Office Action Summary

10/658,116

WILLIS ET AL.

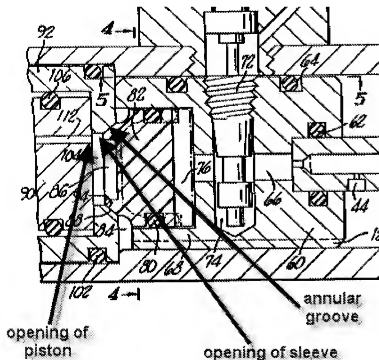
Claims 36-44, 46, and 48-51 are rejected under 35 U.S.C. 102(b) as being anticipated by McKinnon et al. (US 5,064,413). McKinnon discloses a device comprising a housing (22) having a proximal end and a distal end, the housing having an opening (the opening of the syringe) proximate the distal end, the opening configured to deliver a fluid, a fluid chamber (syringe chamber) disposed inside the housing and configured to contain the fluid, a propellant chamber (28) disposed inside the housing and spaced from the distal end, a sleeve (92) disposed inside the housing between the distal end and the propellant chamber and having a first cavity (lumen of 92), the first cavity being in fluid communication with the propellant chamber (the lumen of 92 and element 28 are in fluid communication during operation of the device), and a piston (90) coupled with the sleeve and having a second cavity (112) in fluid communication with the first cavity, the piston being movable with respect to the sleeve from a first position to a second position, the piston configured to compress the fluid chamber upon moving from the first position to the second position, wherein the sleeve and piston include at least one opening that are alignable with each other and further wherein the sleeve includes an annular groove with the opening disposed in the groove (see reproduced drawing below), wherein the piston (90) includes at least two openings that are axially spaced from each other, wherein the housing includes a plurality of housing components (the device can be considered to have a plurality of housing components), wherein the propellant chamber includes a propellant (gas), wherein the opening of the piston is not in fluid communication with an exterior of the housing in the first position and being in fluid communication in the second position, wherein the fluid

chamber includes a plunger (96), wherein the device is a needleless syringe, wherein the piston is coaxial with the sleeve, and further comprising a filter (40).

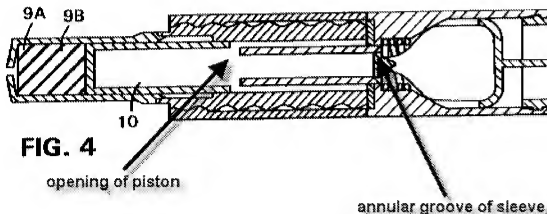
Willis discloses a device comprising a housing (1,2,3) having a proximal end and a distal end, the housing having an opening (13) proximate the distal end, the opening configured to deliver a fluid, a fluid chamber (13b) disposed inside the housing and configured to contain the fluid, a propellant chamber (6) disposed inside the housing and spaced from the distal end, a sleeve (element defining 11) disposed inside the housing between the distal end and the propellant chamber and having a first cavity (11), the first cavity being in fluid communication with the propellant chamber, and a piston (10) coupled with the sleeve and having a second cavity (lumen of 10) in fluid

communication with the first cavity, the piston being movable with respect to the sleeve from a first position to a second position, the piston configured to compress the fluid chamber upon moving from the first position to the second position, wherein the sleeve and piston include at least one opening that are alignable with each other and further wherein the sleeve includes an annular groove with the opening disposed in the groove (see reproduced drawing below), wherein the housing includes a plurality of housing components (the device can be considered to have a plurality of housing components), wherein the propellant chamber includes a propellant (gas), wherein the opening of the piston is not in fluid communication with an exterior of the housing in the first position and being in fluid communication in the second position, wherein the fluid chamber includes a plunger (9a, 9b), wherein the device is a needleless syringe, and wherein the piston is coaxial with the sleeve.
